Title (customer effect) REQUEST REGEN Button Missing From EATS Status and DPF Status Screens In Instrument Cluster (IC) - Chassis Equipped With New (Updated) Cluster Design - **Model Year 2018 And Newer**

Cause Model year 2018 (Generation 2) Chassis may not display the REQUEST REGEN button on the EATS Status and DPF Status screens in the instrument cluster. This may occur following a software update.

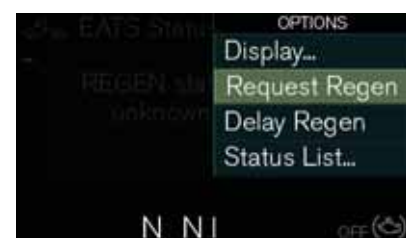
Solution An update to the Instrument Cluster software changed the location of the option to request a Parked Regeneration in the Aftertreatment screens in the driver display on units equipped with new style (color display) clusters.

Previously, the REQUEST REGEN button was located at the bottom of the screen on both the EATS Status and DPF Status menus as shown below:

Following the update, the option to request a Parked Regen is no longer present directly on the Status screens:

Request Regen is now included in the OPTIONS menu off of each of these screens as seen below. The function can only be selected if a parked regeneration is required, and is locked out if the unit is not stationary.
